# DT-24A Dishwashing Trailer

## INSPECTION REPORT

## INSPECTION OBSERVATION REPORT

## 6. Plumbing View

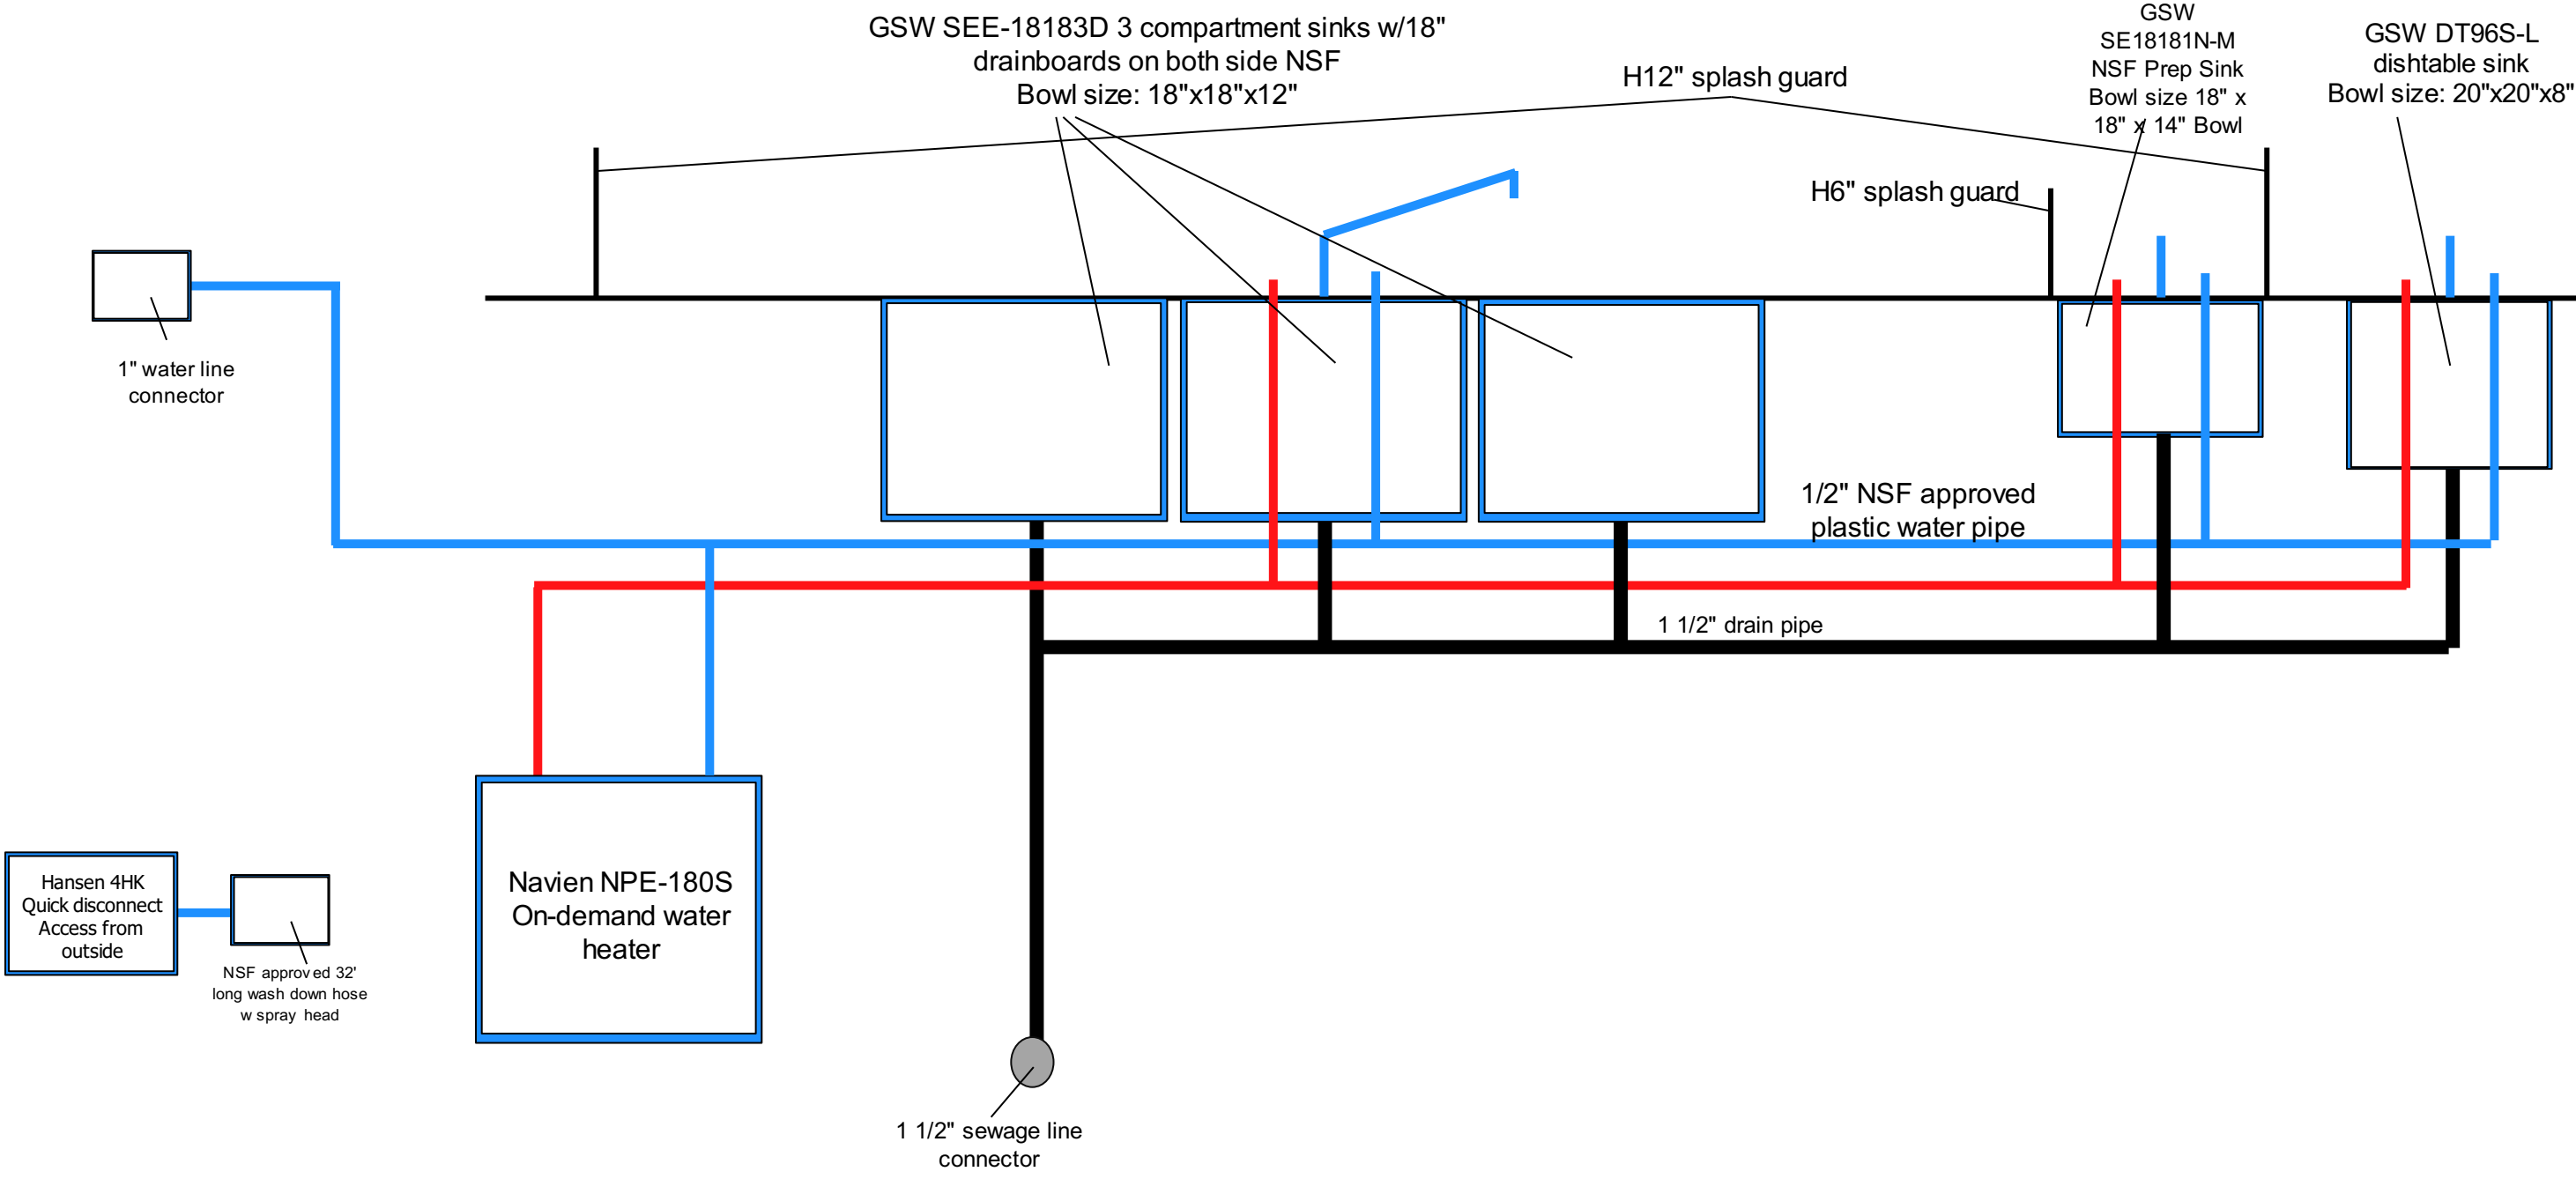
SERIAL NUMBER	DAPIA/CCI/MCI CODE REF.	OBSERVATIONS/COMMENTS
100673		This inspection is for the state of California spec.
		This unit is for emergency diversion relief. This unit only washes dishes. There is no fresh water or gray water tanks due to the high volume of water needed for cleaning dishes, it will be hooked up to <del>water</del> utilities when in use.
		Checked sinks Dishwasher Gal Base disposal tankless water heater main electrical panel.
	MCI	Deficiencies:
1)	51.1	per the manufacturers instructions the air intake and the exhaust for tankless water heater waste close 3 inches apart they need to be 36 inches. Has not fixed and remain.
